TO:	Rabbiah Sabbakhan
	Department of Permitting Services
FROM:	Chris Berger
	Historic Preservation Section
	Maryland-National Capital Park & Planning Commission
SUBJECT:	Historic Area Work Permit # 1060757 - shared-use path

The Montgomery County Historic Preservation Commission (HPC) has reviewed the attached application for a Historic Area Work Permit (HAWP). This application was **approved** at the March 20, 2024, HPC meeting.

The Montgomery County Department of Transportation (MCDOT) recently completed the 35% design phase of the Heritage Triangle Trail - Phase 1 Doctor Bird / Norwood Road Sidepath Project. The project provides a well-connected pedestrian and bicycle network sidepath along Doctor Bird Road (MD 182) and Norwood Road (MD 182). The project limits, shown below in Figure 1, complete two missing links in the bicycle network and provide a pedestrian and bicycling space where none exists today by adding the following:

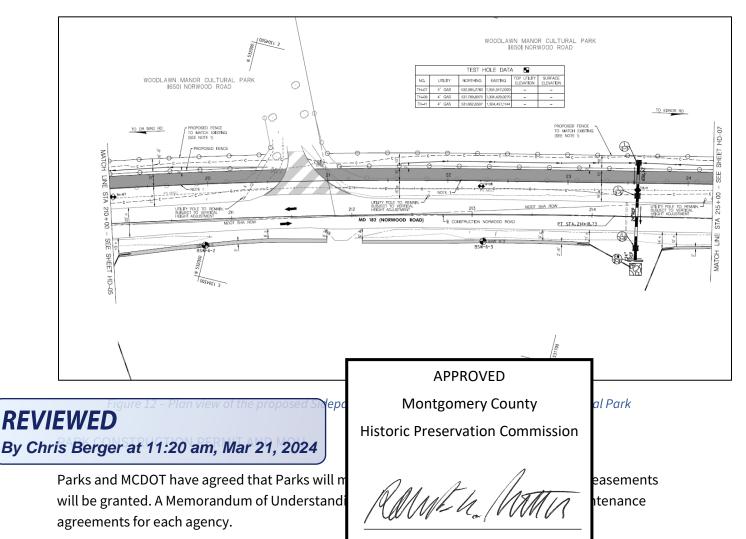
Cultural Park, however the new path does present new challenges for safety and security. Figure 12 shows the proposed shared-use path plan view at the entrance to Woodlawn Manor. Parks Staff have noted concerns with the vehicular traffic utilizing this entrance as a cut-through and additional measures should be taken to improve the safety of the path crossing including better signage to reduce thru traffic, a marked crossing and detectable warning strips for pedestrian and cyclists, and other appropriate measures identified during detailed design. The existing signage at the entrance to Woodlawn will need to be relocated and replaced at the direction of Parks Staff.

horses and path users. The fence must match the existing fence in design and materials. In addition, due to increased access and activity that the path will provide around the Park Police headquarters and equestrian facilities MCDOT will also provide four security cameras along the frontage of the Woodlawn Property. Finally, MCDOT will provide a trail counter along this section of the path to Parks' specification to allow for user data tracking and analysis.
